Subject: MHI's Responses to US-APWR DCD RAI No. 741-5688 (SRP 05.04.11)

Response to Request for Additional Information No. 741-5688,
Revision 0

RAI NO.: NO. 741-5688 REVISION 0
SRP SECTION: 05.04.11 - PRESSURIZER RELIEF TANK
APPLICATION SECTION: 5.4.11
DATE OF RAI ISSUE: 4/27/2011

- Tier1
Figures 2.4.2-2, 2.4.4-1, 2.4.5-1 and 2.4.6-1 show the RCPB interface, as indicated by the below excerpts from these figures. In these figures, "1" indicates the ASME Code Class 1 boundary.

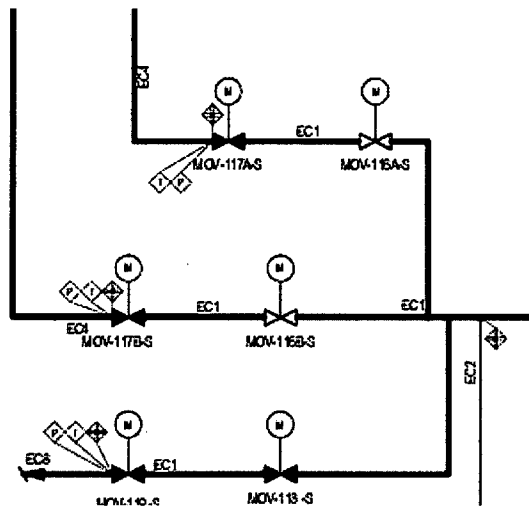
In DCD Tier 1, Subsections 2.4.1 and 2.4.2, Tier 2, Chapter 3, "Design of Structures, Systems, Components, and Equipment," and Subsection 5.4.11, the staff could not find sufficient information to satisfy acceptance criterion which states: at the interface between Seismic Category I and non-Seismic Category I SSCs, the Seismic Category I dynamic analysis requirements should be extended to either the first anchor point in the non-seismic system or a sufficient distance into the non-Seismic Category I system so that the Seismic Category I analysis remains valid. (1) Identify the reference and provide a discussion that supports your position in respect to Regulatory Position C.3 of RG 1.29. (2) From the subsections noted above, how are the reactor coolant pressure boundary (RCPB) components identify from the non-RCPB at the point of interface?

US-APWR DCD Revision 3 figures show RCPB to non-RCPB interface in the following manner:
